SUBDIVISION COMMITTEE
METROPOLITAN AREA PLANNING COMMISSION

STAFF REPORT
(One-Step Final Plat)

CASE NUMBER: S/D 98-102 - WOODLAND GLEN ADDITION

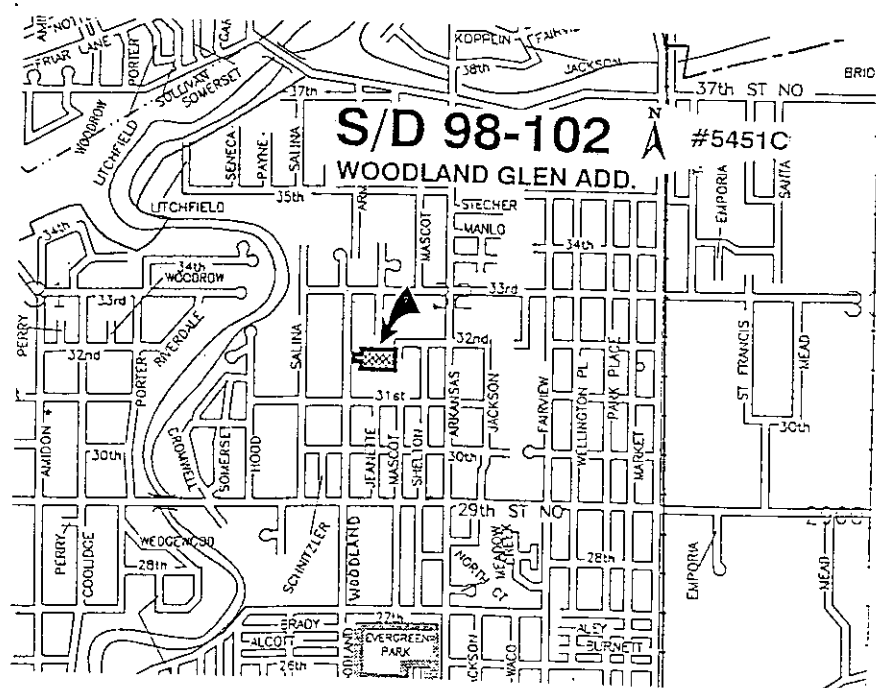
Note: MAPD encourages infill plats, however the lots in this plat face an east-west street contrary to the established pattern in the area; and which impedes the continuation of Jeanette St. northward. Therefore, adjoining landowners were notified. The interior street has been platted at a width of 60 feet which conforms with the right-of-way width for streets in this area.

- K. A street name should be designated for the proposed interior street, which needs to be approved by City Fire Department.
- L. This property is within a zone identified by the City Engineers' office as likely to have groundwater at some or all times within 10 feet of the ground surface elevation. Building with specially engineered foundations or with the lowest floor opening above groundwater is recommended, and owners seeking building permits on this property will be similarly advised. More detailed information on recorded groundwater elevations in the vicinity of this property is available in the City Engineers' office.

- O. Traffic Engineering and/or Fire Department needs to comment on the need for a turnaround for Jeanette adjoining the south line of Lot 3, Block 2.
- P. The applicant shall install or guarantee the installation of all utilities and facilities which are applicable and described in Article 8 of the MAPC Subdivision Regulations. (Water service and fire hydrants required by Article 8 for fire protection shall be as per the direction and approval of the Chief of the Fire Department.)

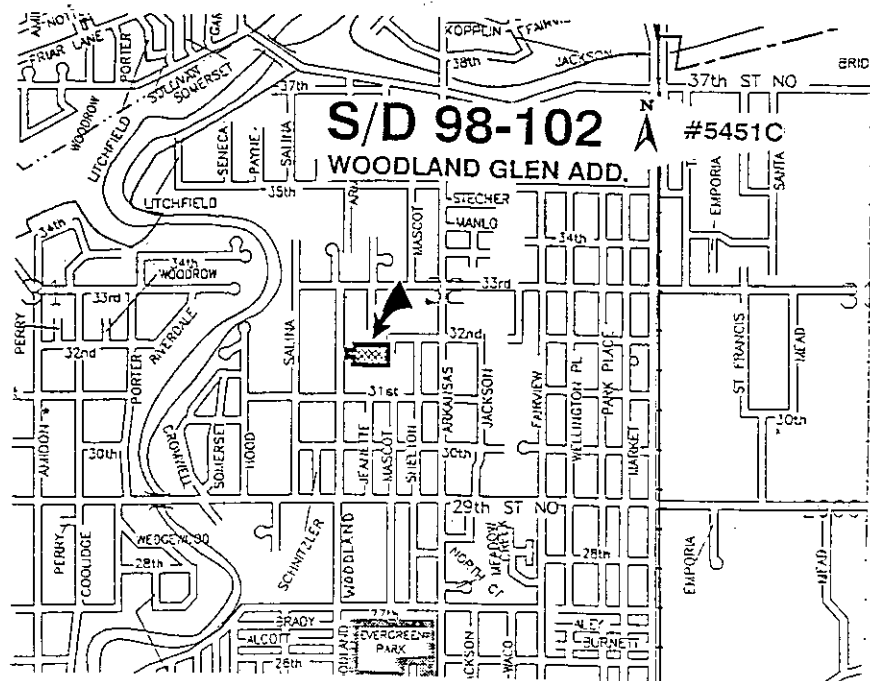
Note: The plat was deferred as the lots in the previous plat faced an interior east-west street contrary to the established pattern in the area; and which impeded the continuation of Jeanette St. northward. The applicant has revised the lot configuration to face the lots toward the north-south Mascot and toward the extended Jeanette Street southward, in addition to platting a contingent street dedication for Jeanette.

- E. The temporary cul-de-sacs need to be established by separate instrument.
- F. The Applicant shall guarantee the paving of the proposed interior street. The roadway width shall be 31 feet back of curb to back of curb.

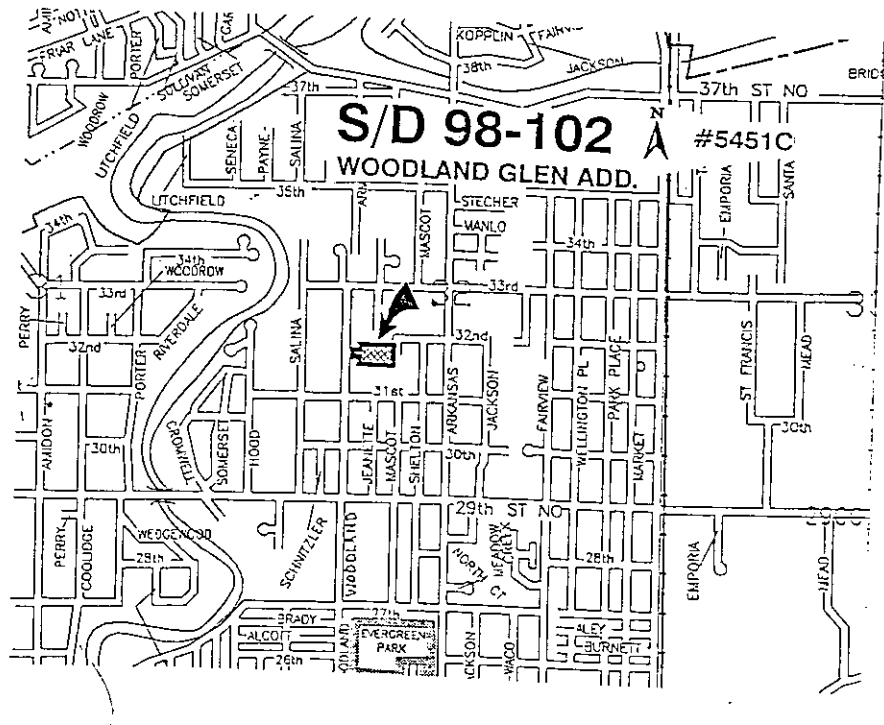
Note: The plat was deferred as the lots in the previous plat faced an interior east-west street contrary to the established pattern in the area; and which impeded the continuation of Jeanette St. northward. The applicant has revised the lot configuration to face the lots toward the north-south Mascot and toward the extended Jeanette Street southward, in addition to platting a contingent street dedication for Jeanette. Temporary turnarounds have been platted for Jeanette and Mascot.

- E. The temporary cul-de-sacs need to be established by separate instrument. It is recommended that the temporary cul-de-sac for Jeanette platted between lots 3 and 2 for Jeanette be a permanent cul-de-sac.

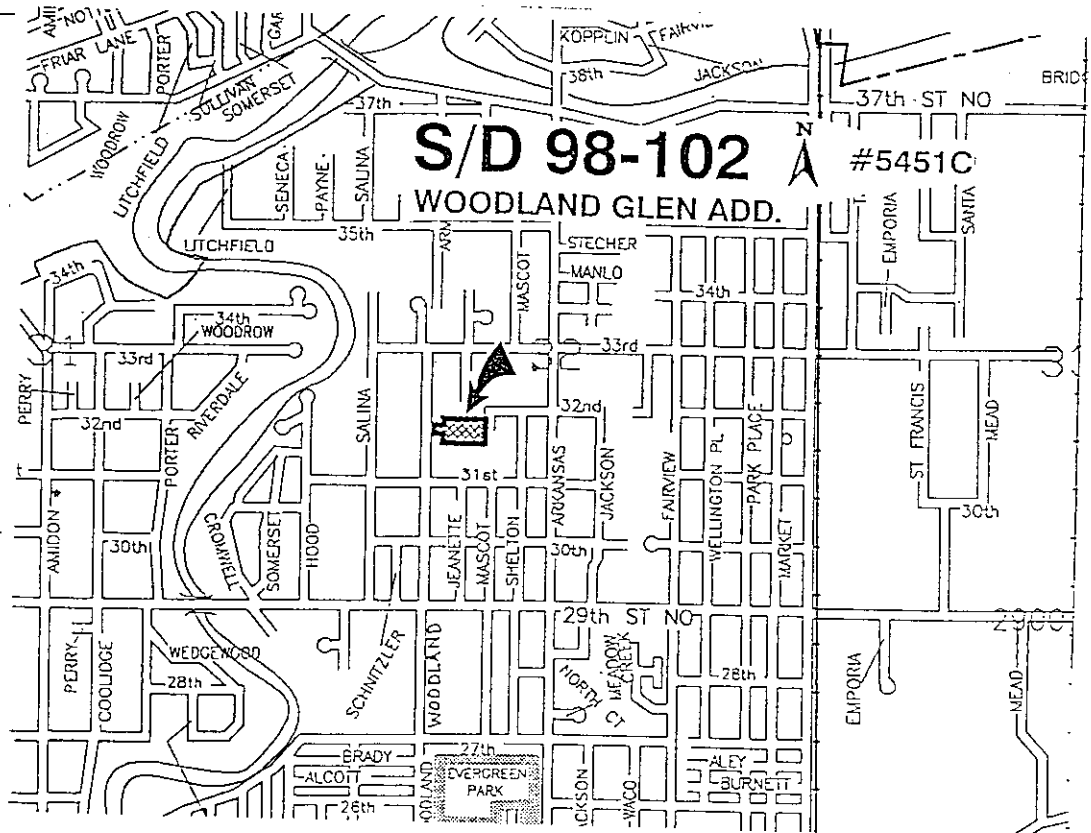
Note: This is an unplatted site located within the City. This revised plat has extended Jeanette northward and southward, eliminated a contingent right-of-way dedication for Jeanette, and reduced the number of lots.

- C. City Engineering needs to comment on the status of the applicant's drainage plan.
- D. The Applicant shall guarantee the paving of the turnarounds for Jeanette. The Applicant shall participate in the petition for the paving of Mascot or submit a No Protest Agreement for its paving.

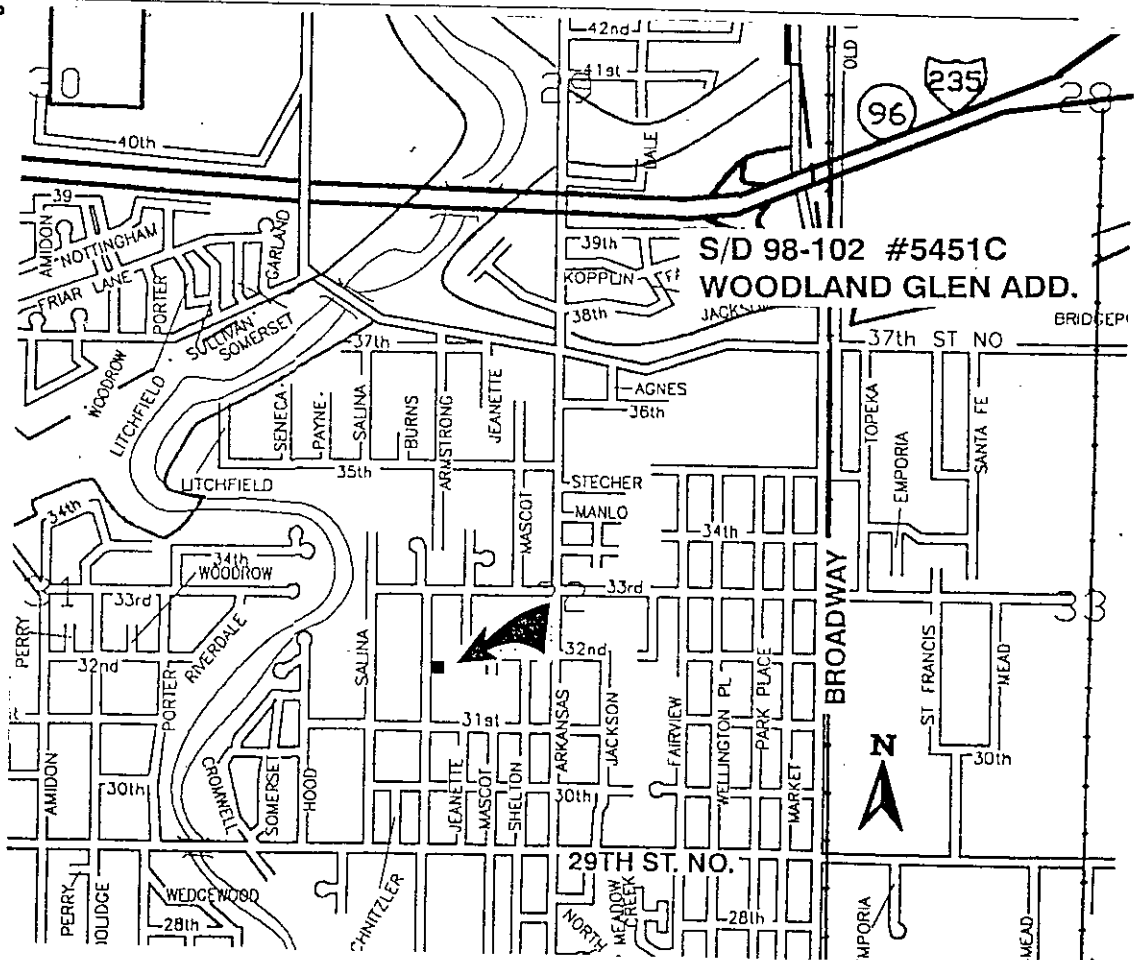
Note: This is an unplatted site located within the City. This revised final plat has eliminated the lots that had extended to Mascot Avenue.
